Cumberland County Subdivision and Land Development Review Report

Municipality:	<u>Shippensburg Boro</u>	Surveyor/ Engineer:	<u>Diffenbaugh Wadel Inc.</u>	Owner/ Developer:	<u>Samuel Cressler</u>
Plat Title:	<u>Gandy Manor</u>				
Plat Status:	<u>Final</u>	Plat Type:	<u>Subdivision</u>		
# of New Lots:	<u>1</u>	# of New Dwelling Units:	<u>12</u>	New Acreage Subdivided/Developed:	<u>0.936</u>
				Total Tract Acreage:	<u>3.625</u>
Zoning District:	<u>Commercial</u>		Proposed Land Use:	<u>Residential</u>	
Date Received:	<u>8/18/2020</u>	County Review:	<u>8/28/2020</u>	Reviewed by:	<u>SH</u>
				Checked by:	<u></u>

FINAL SUBDIVISION PLAN FOR GANDY MANOR & FINAL LAND DEVELOPMENT PLAN FOR GANDY MANOR PHASE 2 (OVERALL PROPERTY & APPROVALS)

FINAL SUBDIVISION PLAN FOR GANDY MANOR & FINAL LAND DEVELOPMENT PLAN FOR GANDY MANOR PHASE 2 (PROPOSED SITE IMPROVEMENTS)

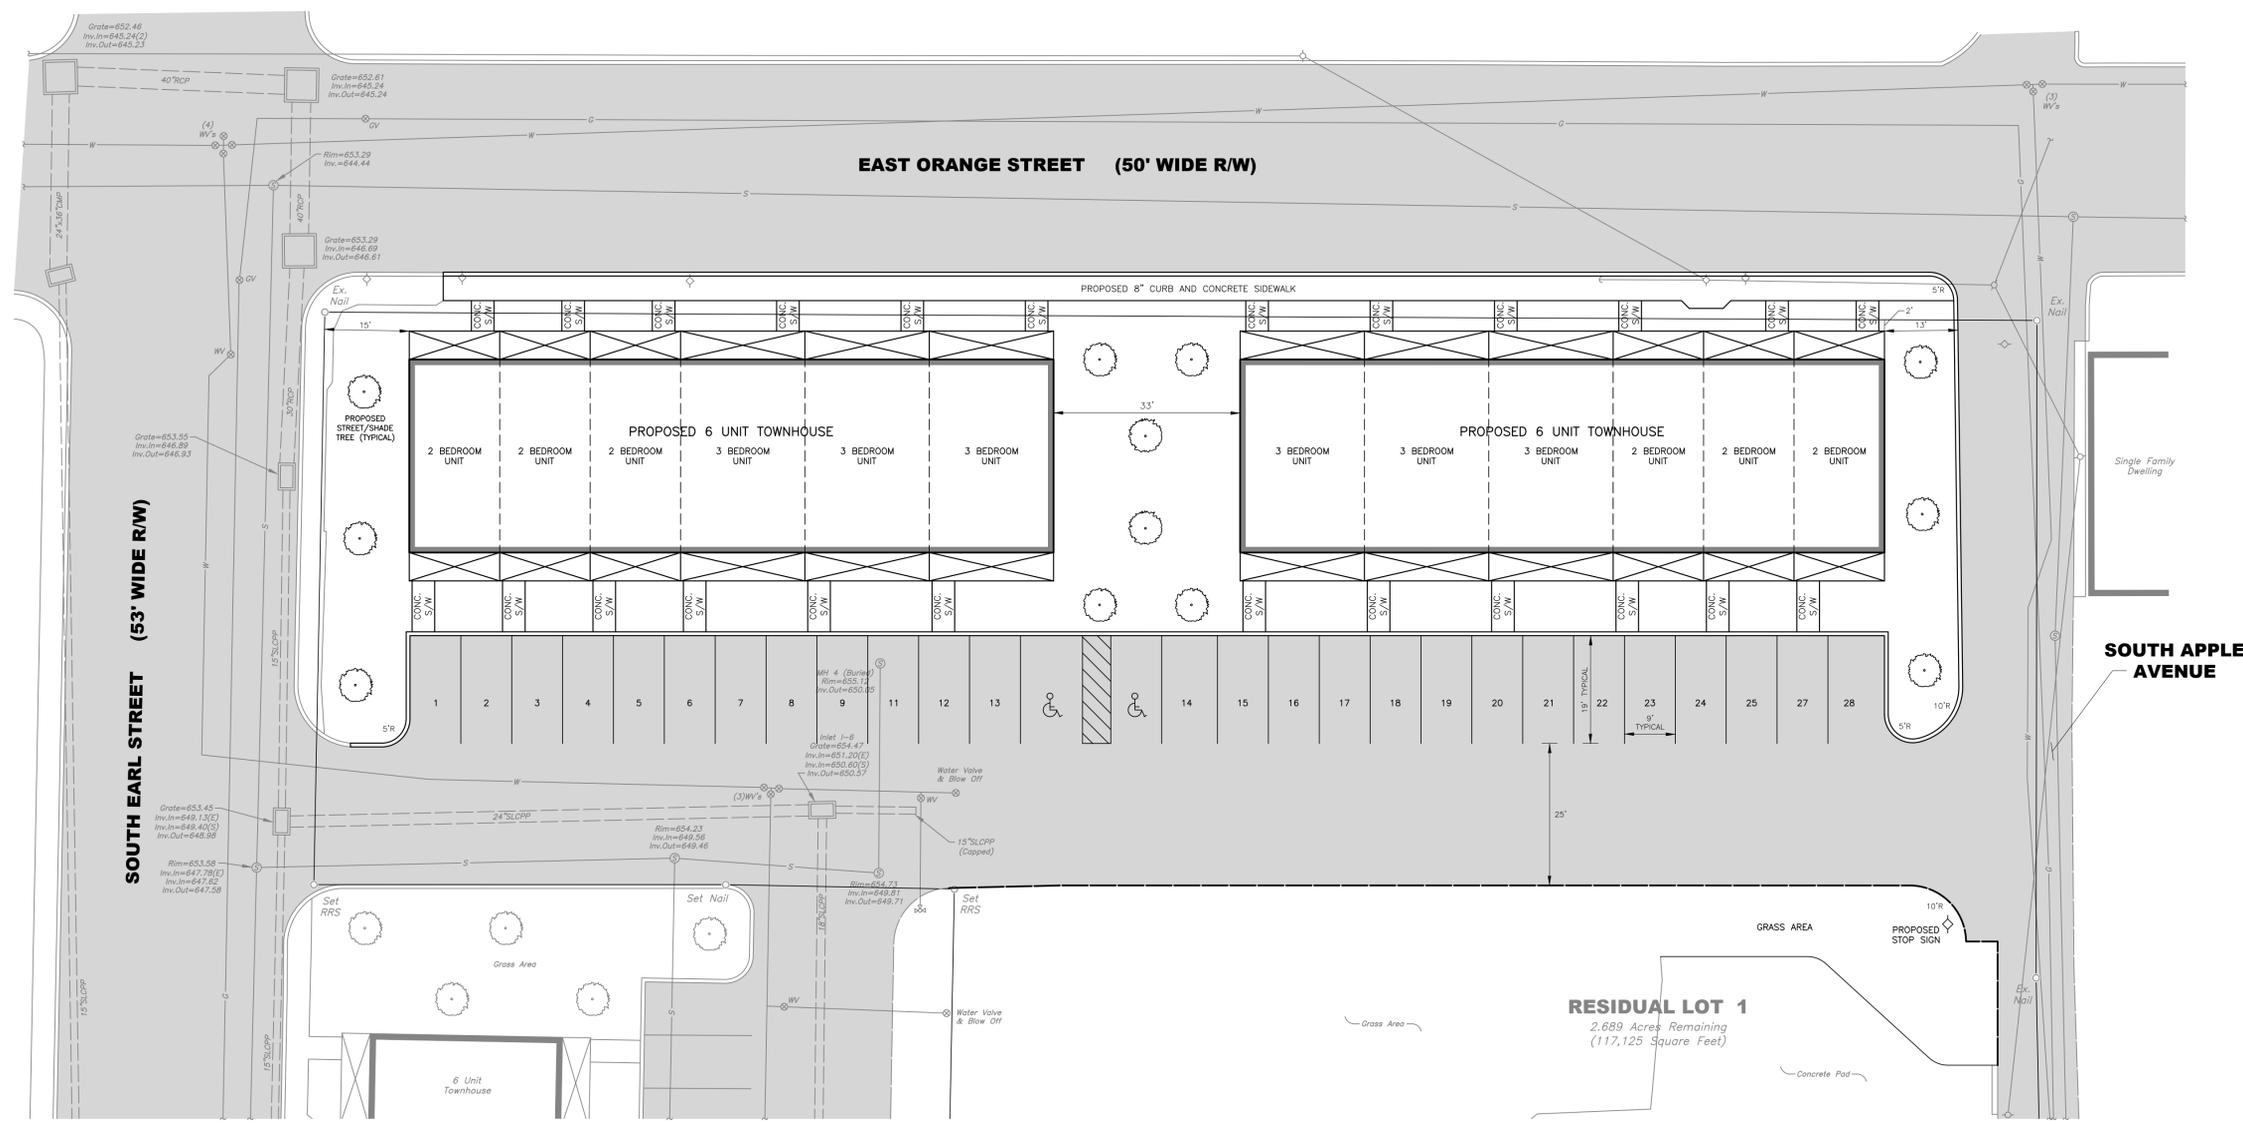
8. The proposed parking spaces appear to be numbered consecutively. Parking space #10 was omitted from the count.
9. Will the remaining portion of the Beistle Building or the warehouse building be demolished as part of the plan? If not, what is the proposed use of these buildings? These buildings should be addressed in the General Notes.
